HISTORIC DISTRICT COMMISSION

Memorandum

Re: Updated 421 W Washington Street HDC application (HDC26-0028)

Proposed Elevations

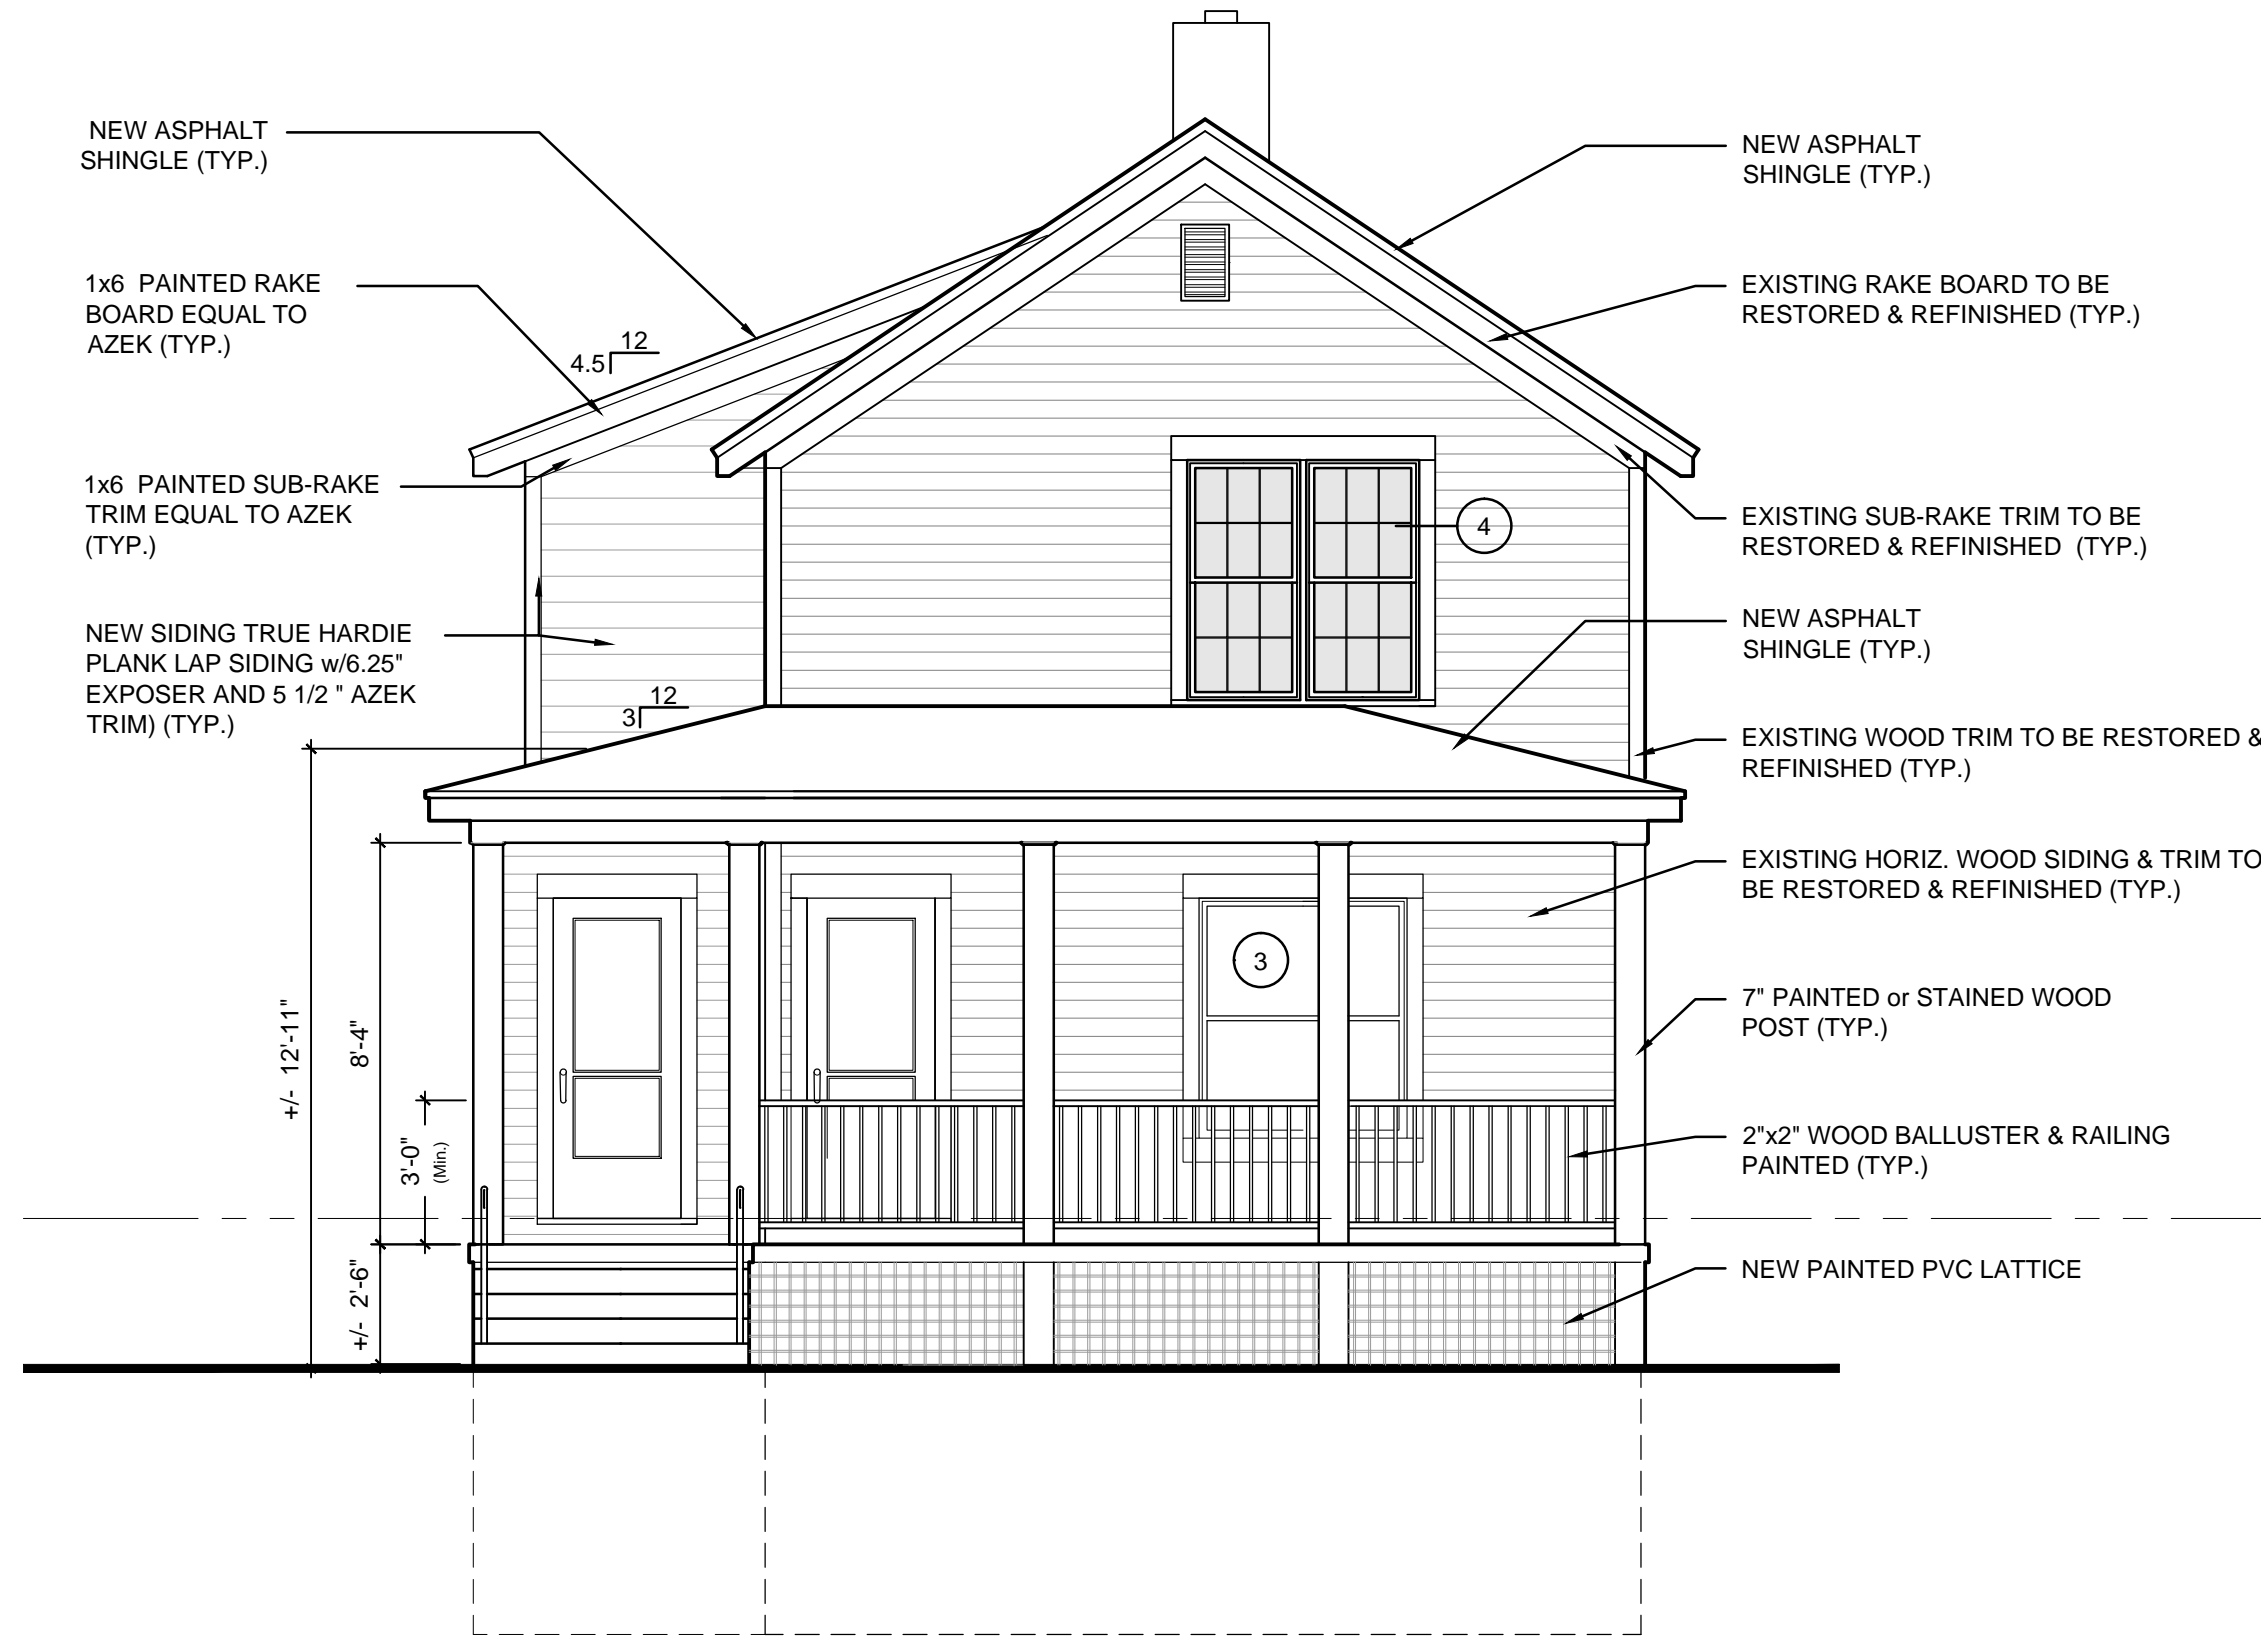
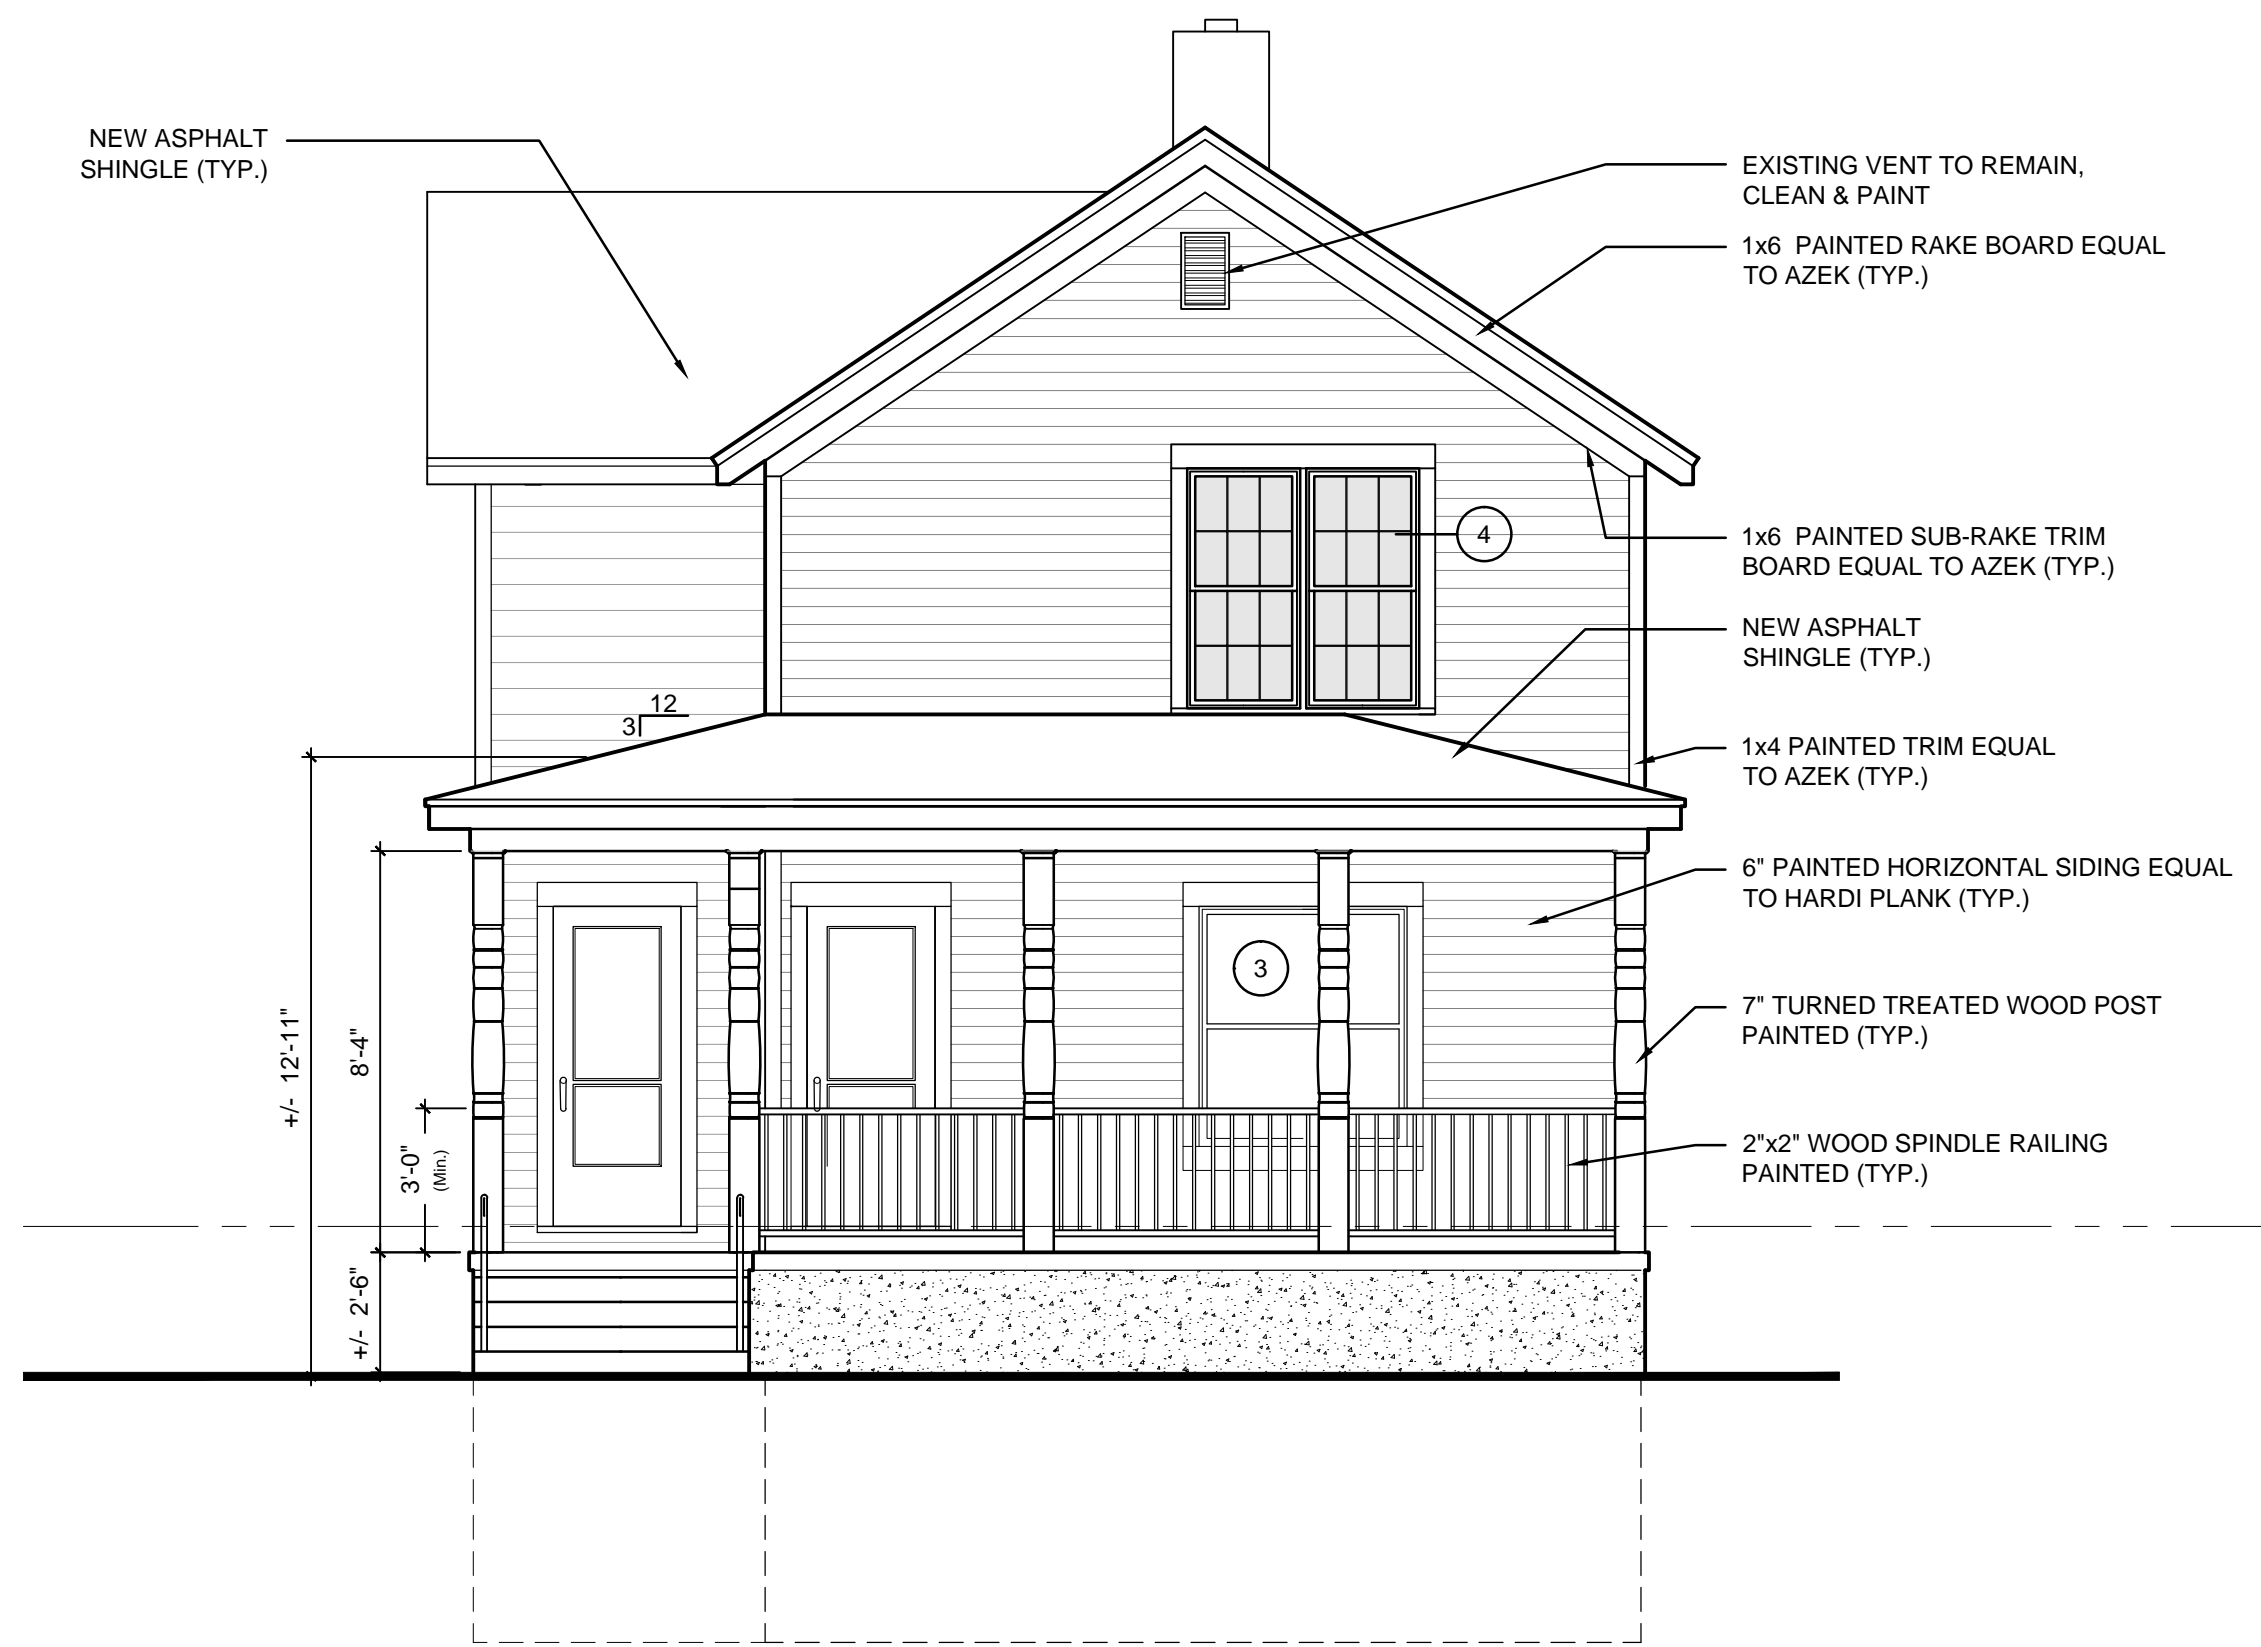
1. The applicant has submitted revised plans showing the east second-story

addition with a shed roof instead of a gable roof to determine if this change would reduce massing and visibility. The addition is also slightly smaller, extending five feet beyond the plane of the east elevation instead of six feet. It will add roughly 72sf off floor area on the second floor instead of 86sf. The rest of the details remain largely the same; the roof will be asphalt shingle and siding will be Hardie plank. Two historic six-over-six windows that would be removed during construction will be reused on the east side of the addition.

The Historic District Commission must determine if the proposed second-story east addition better meets the Standards and Guidelines with the shed roof and smaller footprint. The materials are appropriate, the square footage is small, and it is lower than the historic roof line. The change in roof shape does minimize the overall bulk of the addition, but the east elevation is still very conspicuous and, though differentiated from the historic house, the second-story addition will be very visible from the right of way.
